AMENDMENTS TO THE DRAWINGS

A marked-up sheet and a replacement sheet are submitted herewith amending Fig. 7.

REMARKS

Marked-up Sheet

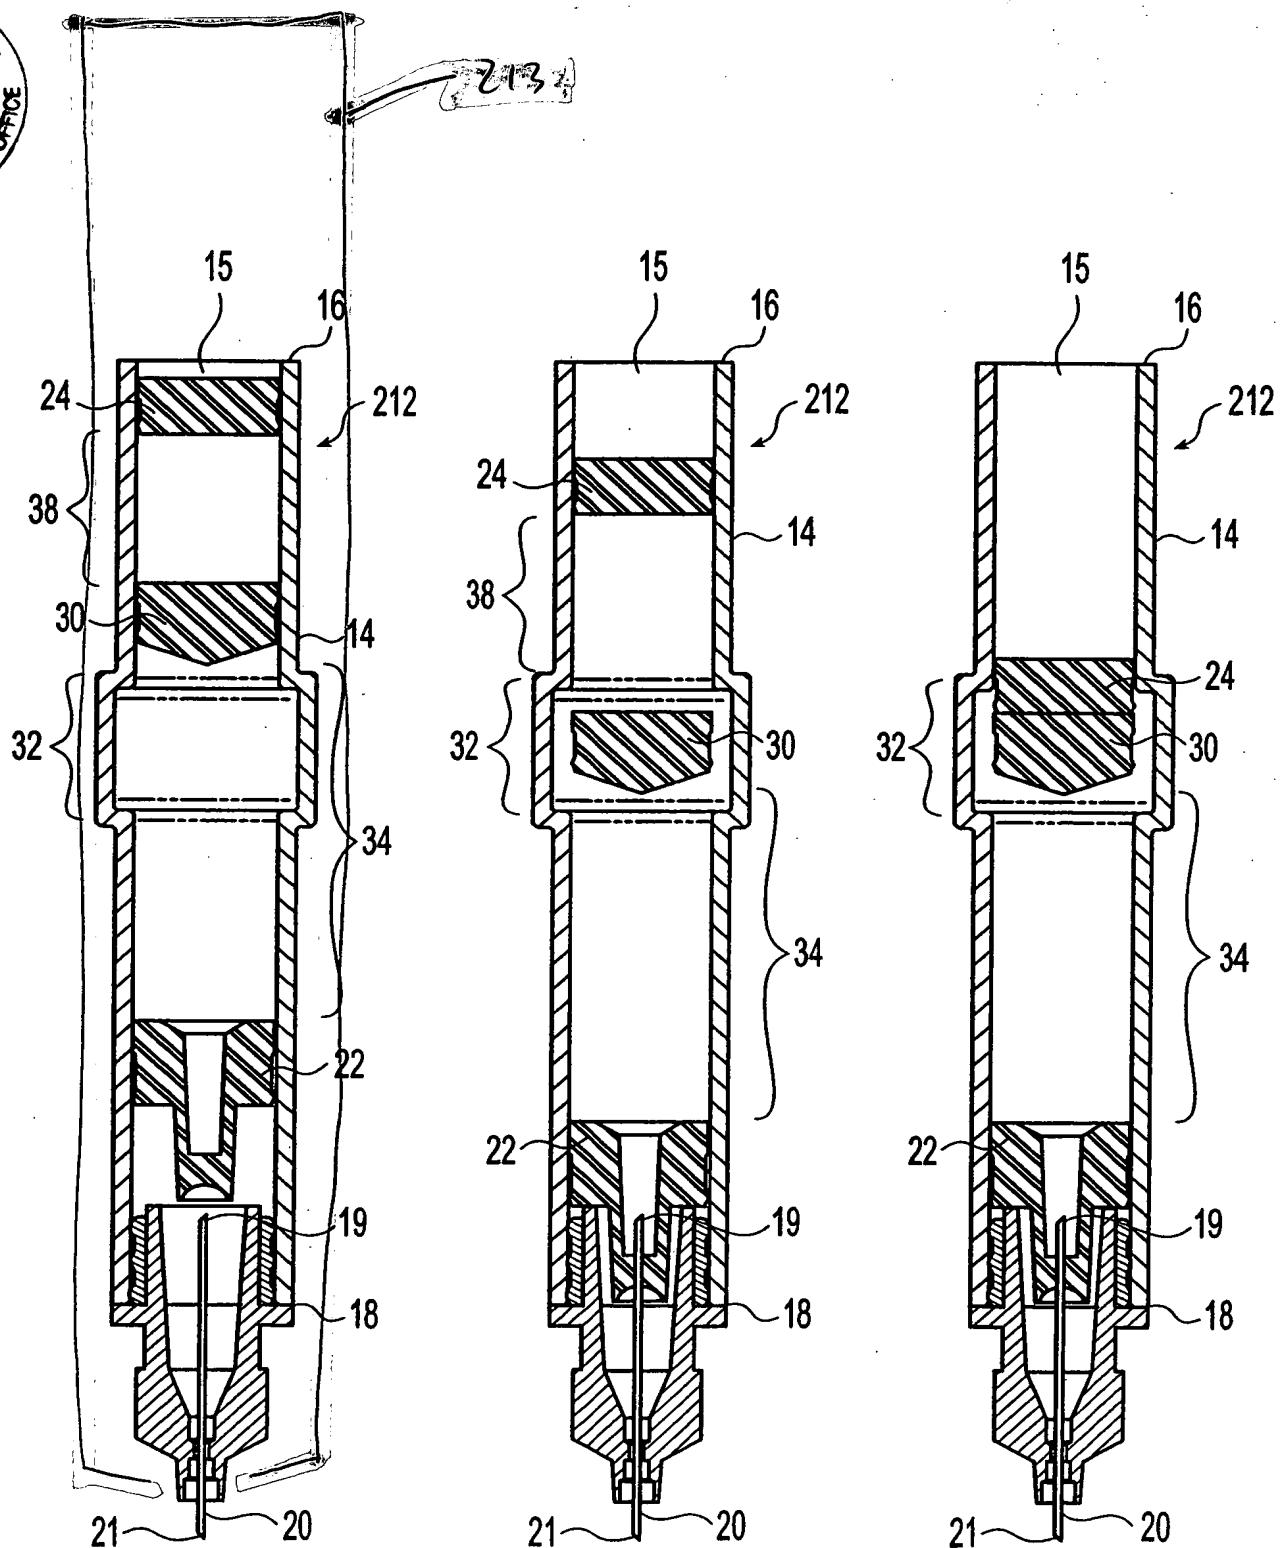
The drawings were objected to for not showing an injection device. Fig. 7 has thus been amended to schematically show such a device, and the specification has been amended accordingly. The amendments are fully supported in the originally filed specification, claims, and drawings, as explained below.
